City of Sandy

Planning Commission Meeting
Meeting Location: Virtual via Zoom
Meeting Date: Monday, October 25, 2021
Meeting Time: 6:30 PM

**PLANNING COMMISSION STAFF REPORT
TYPE III LAND USE PROPOSAL**

EXHIBIT C "THE BORNSTEDT VIEWS"

SITE LOCATION AND FUTURE STREET PLAN
SCALE: 1" = 100'

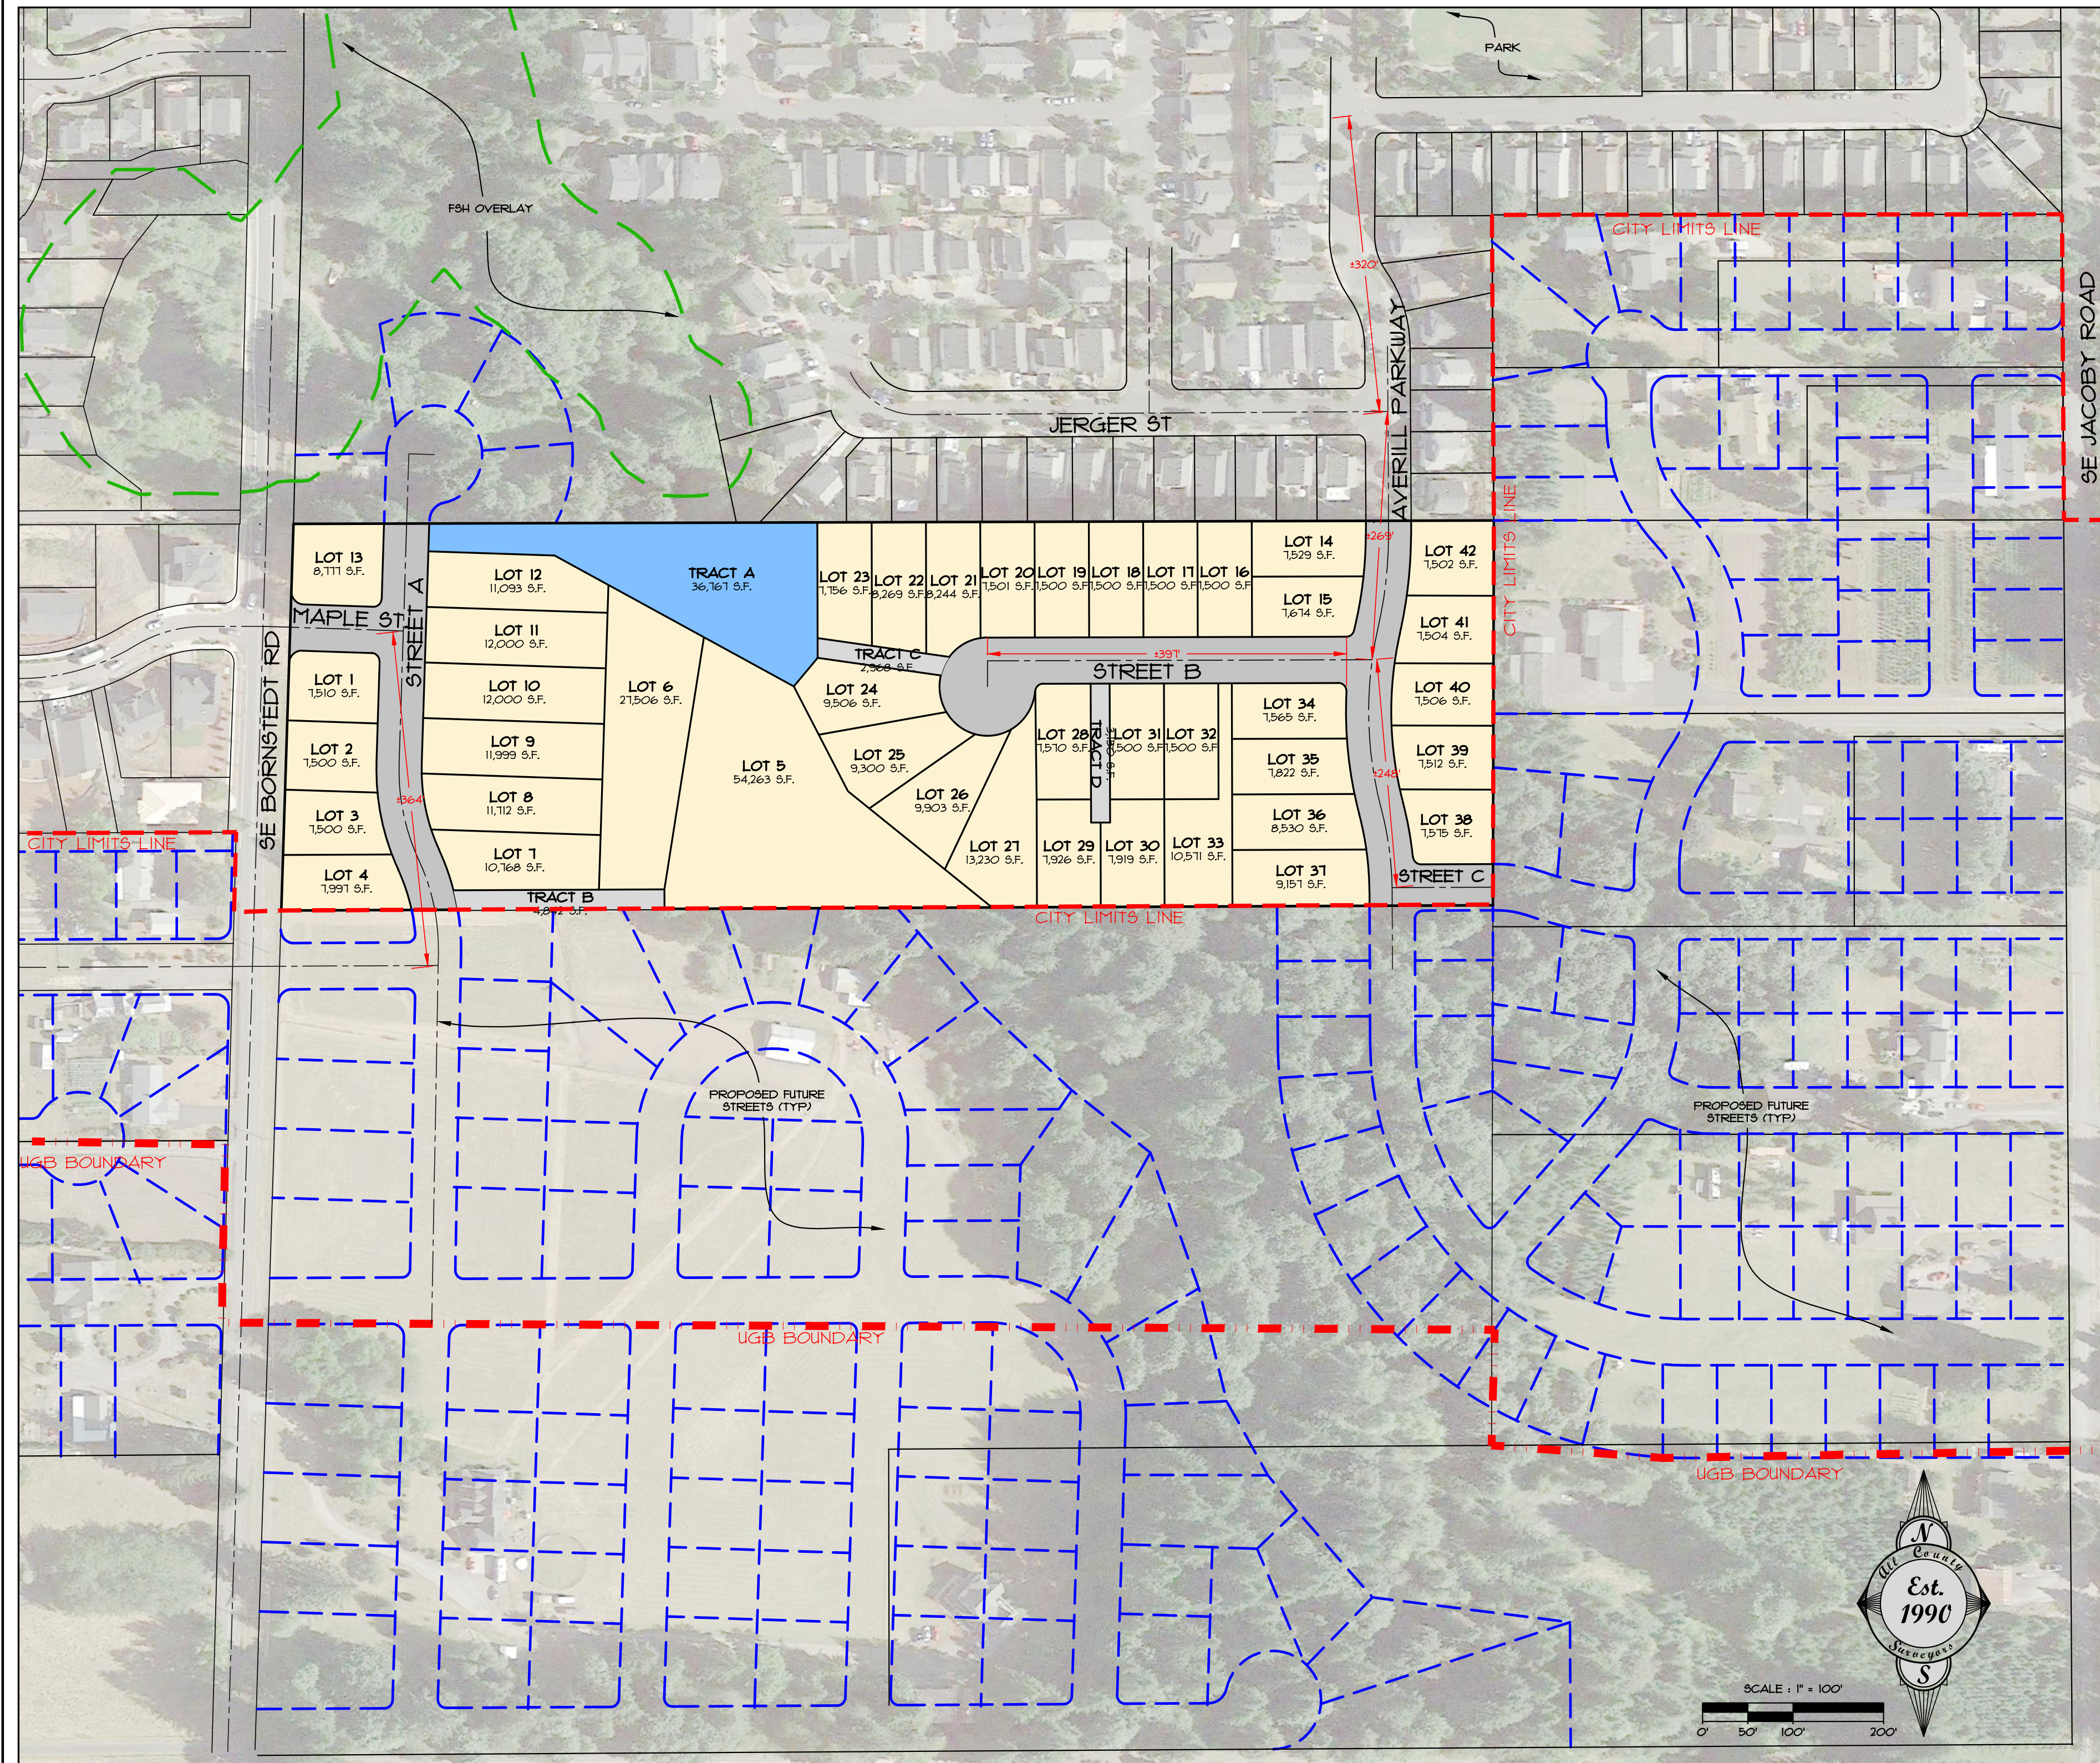
- F. The applicant did not submit information on block lengths for all blocks. The Site Location and Future Street Plan (Exhibit C, Sheet C1) details block lengths for some blocks, but not all blocks. The narrative (Exhibit B) states the block length standards in Section 17.100.120 are subjective (i.e., not clear and objective) and because the subdivision constitutes a needed housing application the block length standards are not

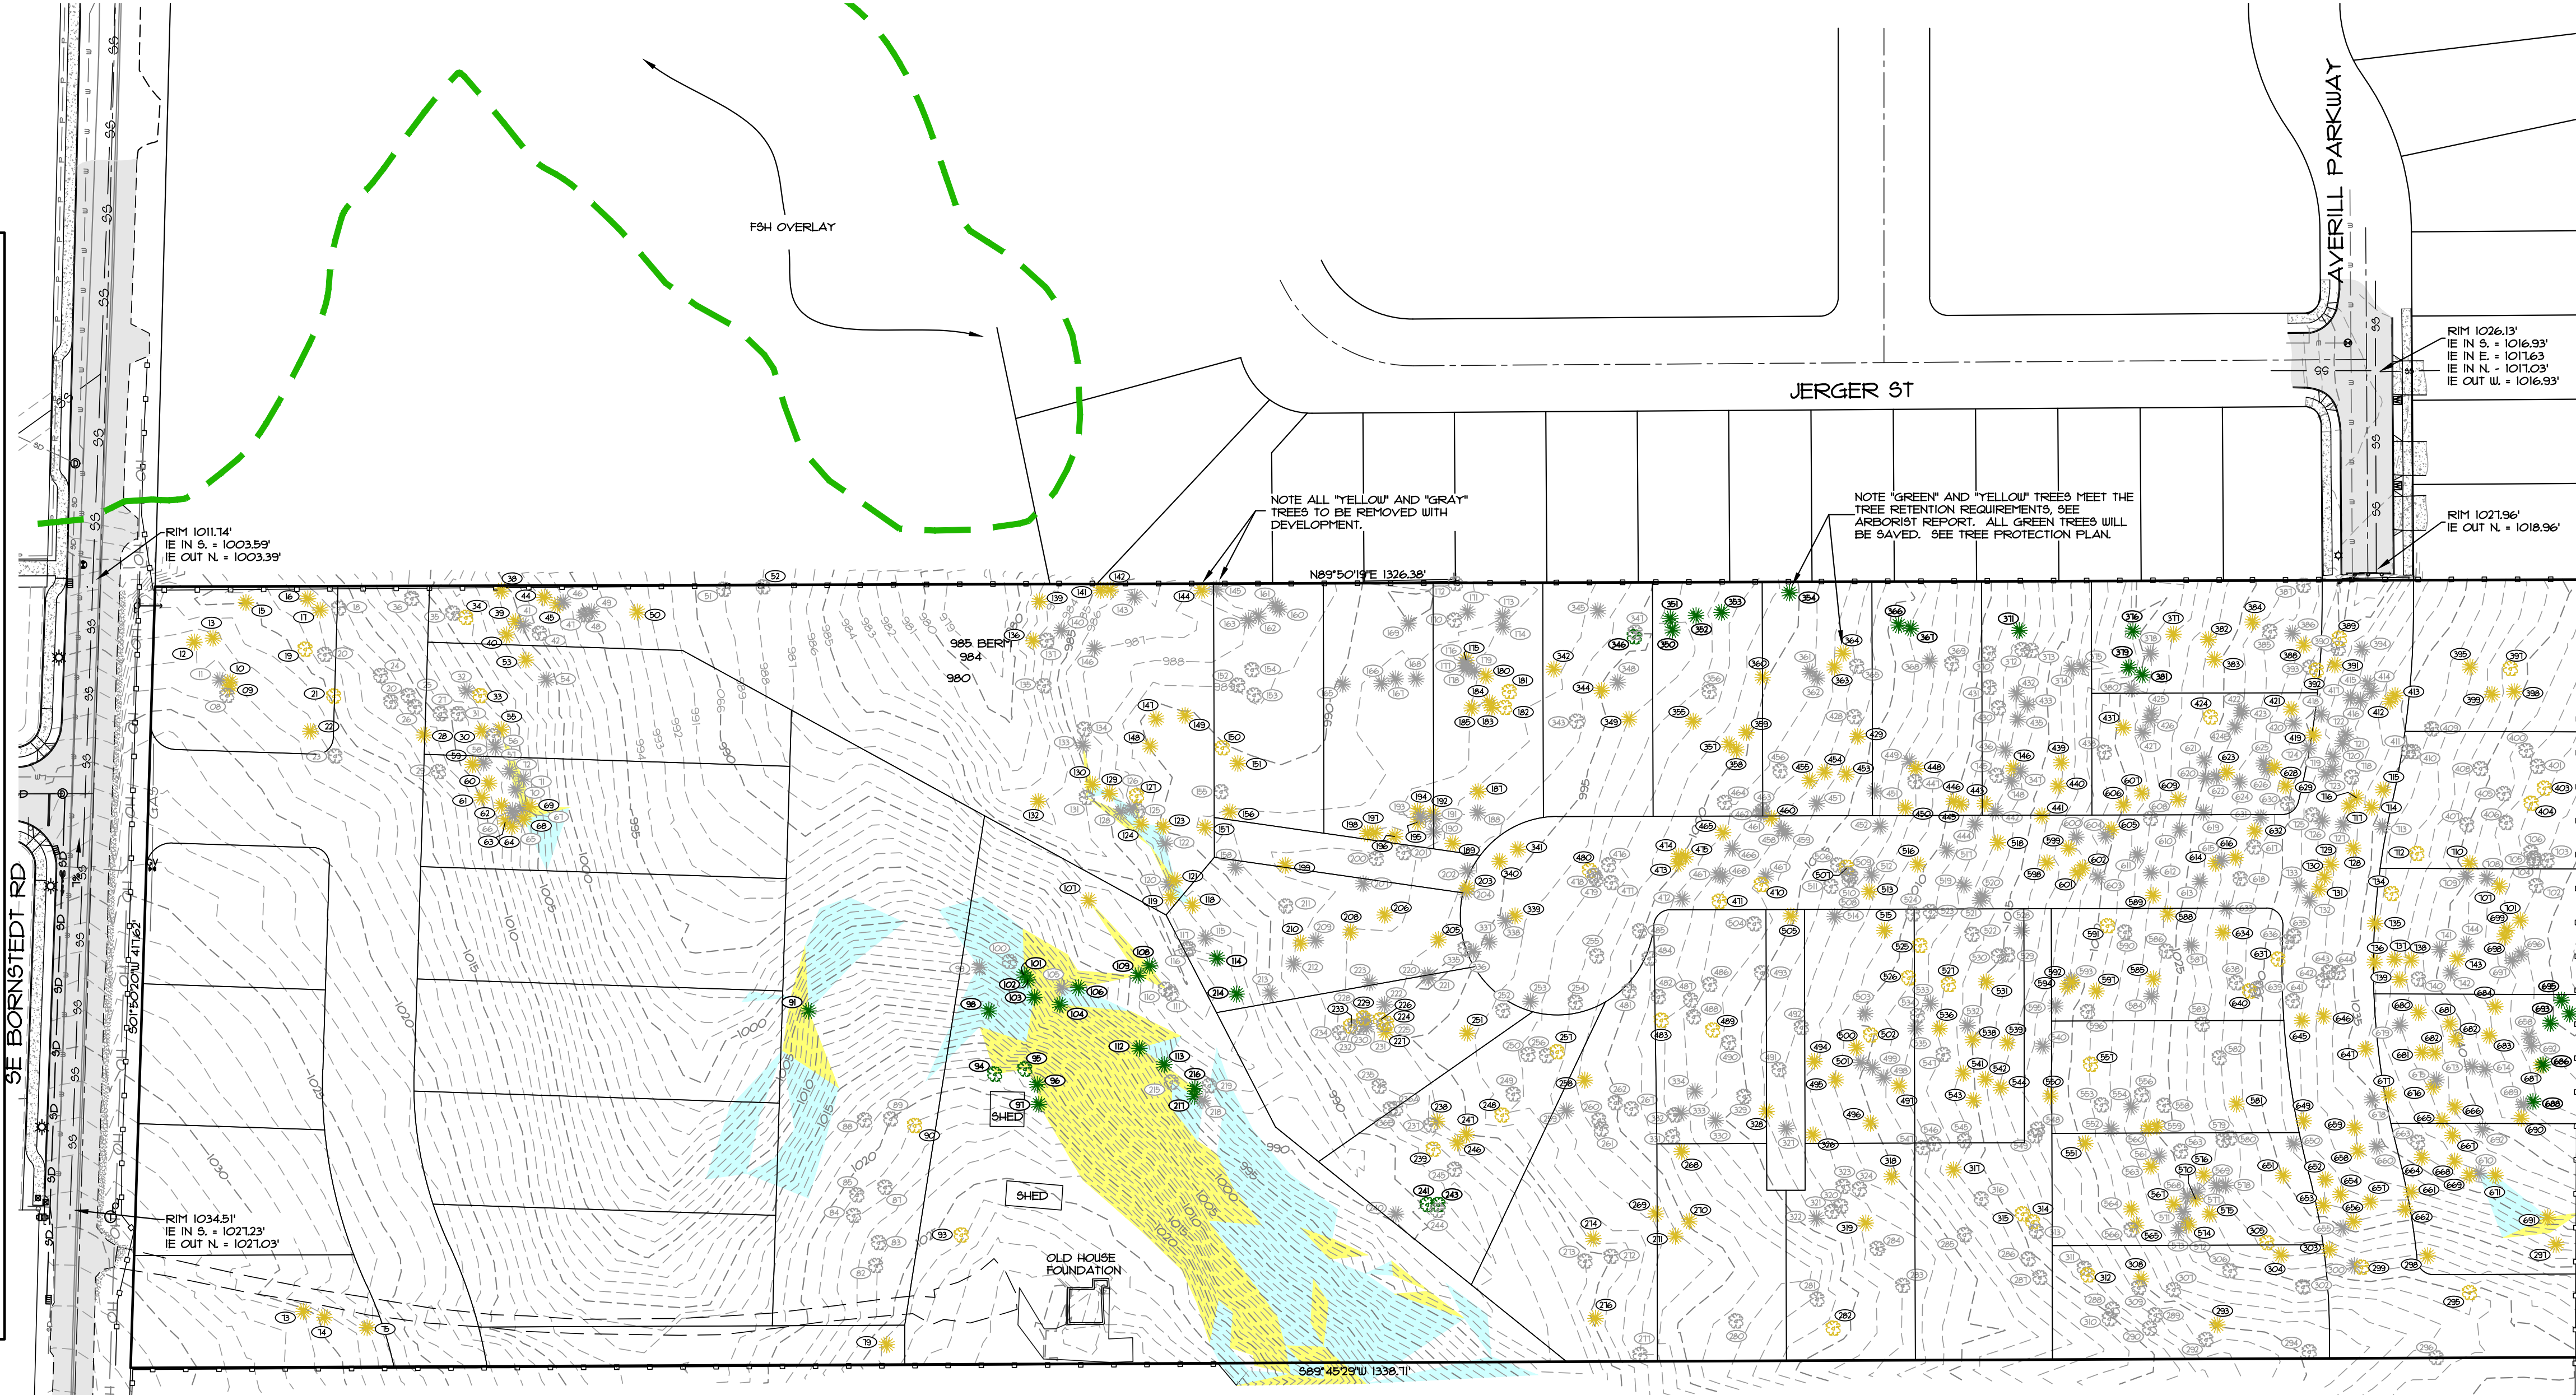
74. The Tree Retention and Protection Plan (Exhibit C, Sheet C7) details several trees being removed from within the critical root zones of trees proposed for retention. These include Trees #99, 100, 105, 110, 11, 115, 116, 117, 118, 119, 213, 215, 218, 219, 345, 347, 361, 364, 365, 368, 369, 370, 372, 373, 378, and 380. **Staff recommends Trees #99, 100, 105, 110, 11, 115, 116, 117, 118, 119, 213, 215, 218, 219, 345, 347, 361, 364, 365, 368, 369, 370, 372, 373, 378, and 380 be left as snags rather than completely removed in order to minimize negative impacts to the remaining retention trees. If the applicant does not retain Trees #99, 100, 105, 110, 11, 115, 116, 117, 118, 119, 213, 215, 218, 219, 345, 347,**

THE BORNSTEDT VIEWS
STREET AND UTILITY PLAN
19618 SE BORNSTEDT ROAD, SANDY, OH

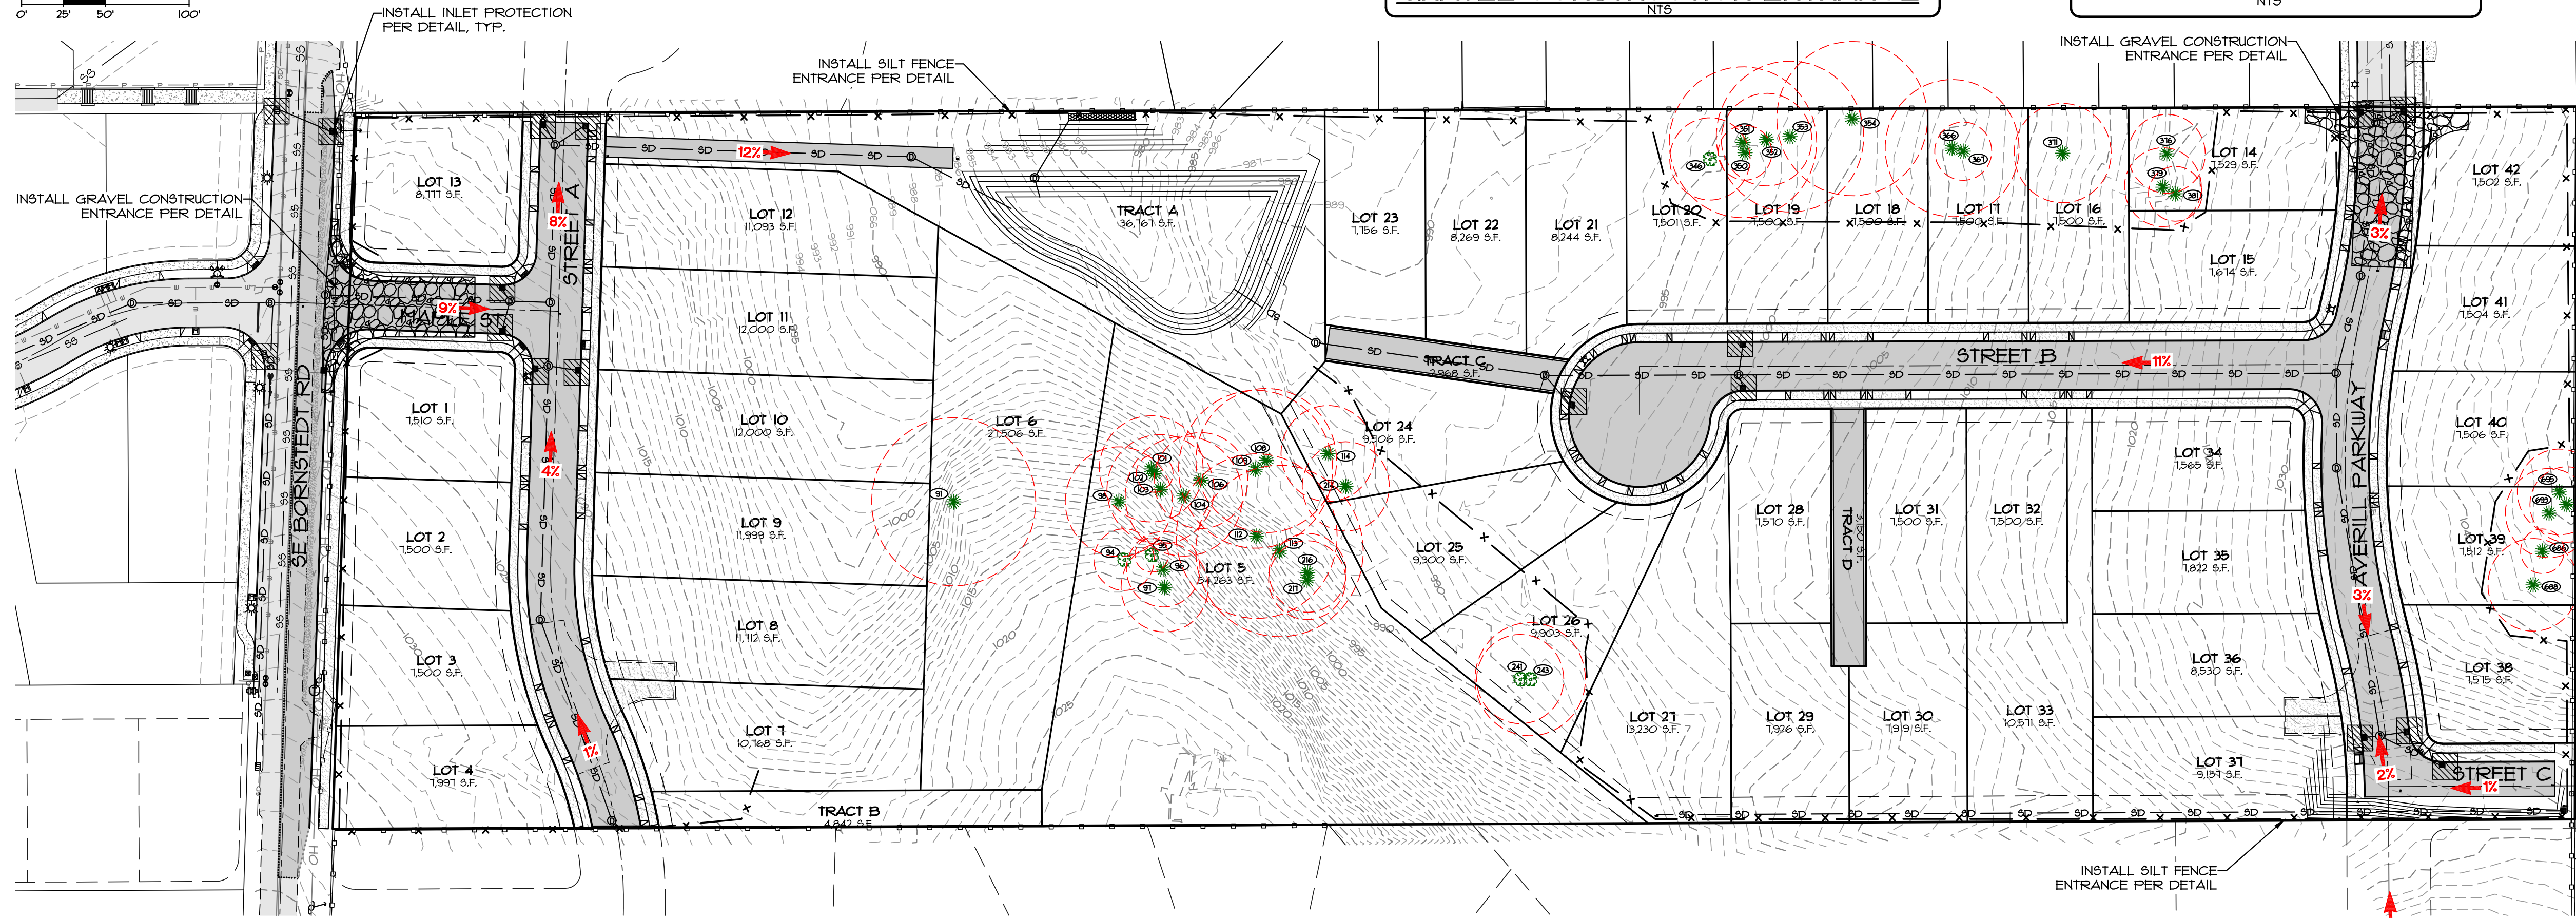
55. Section 17.84.60 outlines the requirements of public facility extensions. The applicant submitted a Street and Utility Plan (Exhibit C, Sheet C8) which shows the location of proposed public water, sanitary sewer, and stormwater drainage facilities. **Broadband fiber service shall be detailed with construction plans.**
